802.3dj D1.0 Comment Resolution Logic Track

Gary Nicholl (Cisco), 802.3dj Chair, Architecture and Logic Track

- This slide package was assembled by the 802.3dj editorial team to provide background and detailed resolutions to aid in comment resolution.

Figure 177–8—Inner FEC pad detection state diagram

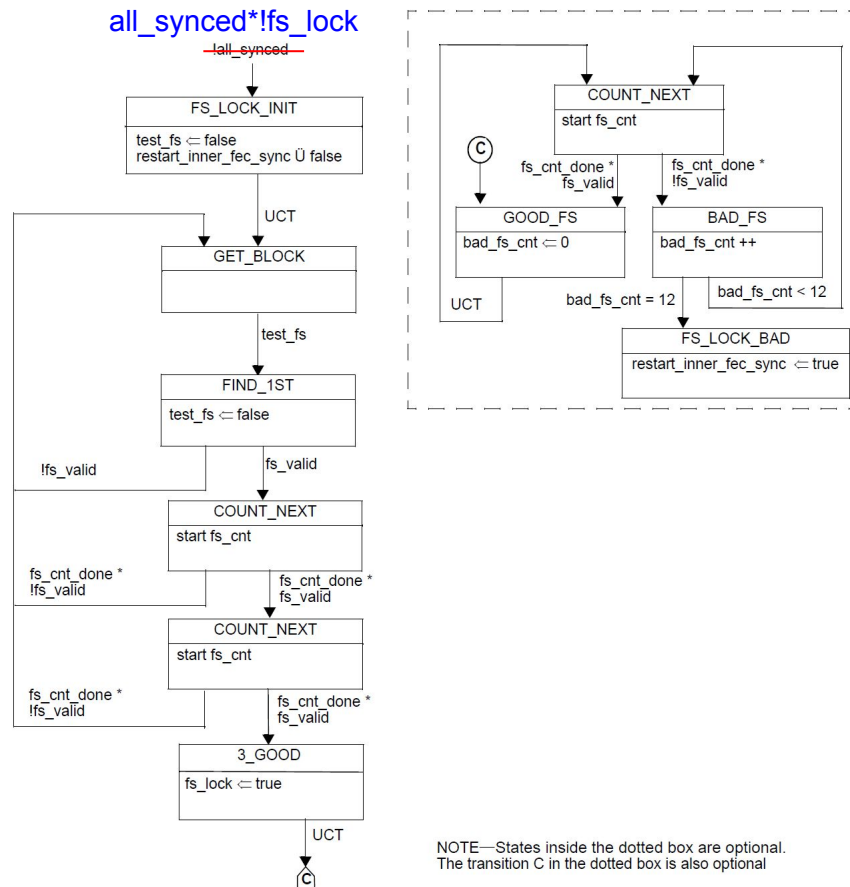
Cl 177	SC 177.6	P 262	L 5	# 505
Ren, Hao		Huawei		
<i>Comment Type</i>	TR	<i>Comment Status</i>	D	<i>Inner FEC Sync</i>
In Figure 177—8, the input variable of state FS_LOCK_INIT is not correct. It would cause a FS lock error.				
<i>Suggested Remedy</i>				
FS_LOCK_INIT state should be entered after all the 8 flows obtain their inner FEC codeword boundaries and inner FEC flow 0 is identified, when fs_lock is false.				
Propose change: Change the input variable from '!all_synced' to 'all_synced * !fs_lock'.				
Change the definition of all_synced from 'A Boolean variable that is set to true when sync_flow<x> is true for all eight flows and is set to false when sync_flow<x> is false for any x.' to 'A Boolean variable that is set to true when inner FEC flow 0 is identified and is set to false when sync_flow<x> is false for any x.' (in page 258 line 48-50)				
<i>Proposed Response</i>		<i>Response Status</i>	W

PROPOSED ACCEPT IN PRINCIPLE.				
Change the condition for FS_LOCK_INIT state from "!all_synced" to "all_synced*!fs_lock"				
Change the definition of variable "all_synced" from: "A Boolean variable that is set to true when sync_flow<x> is true for all eight flows and is set to false when sync_flow<x> is false for any x." to: " A Boolean variable that is set to true when sync_flow<x> is true for all eight flows AND inner FEC flow 0 is identified, and is set to false when sync_flow<x> is false for any x."

Change Figure 177-8 as follows:
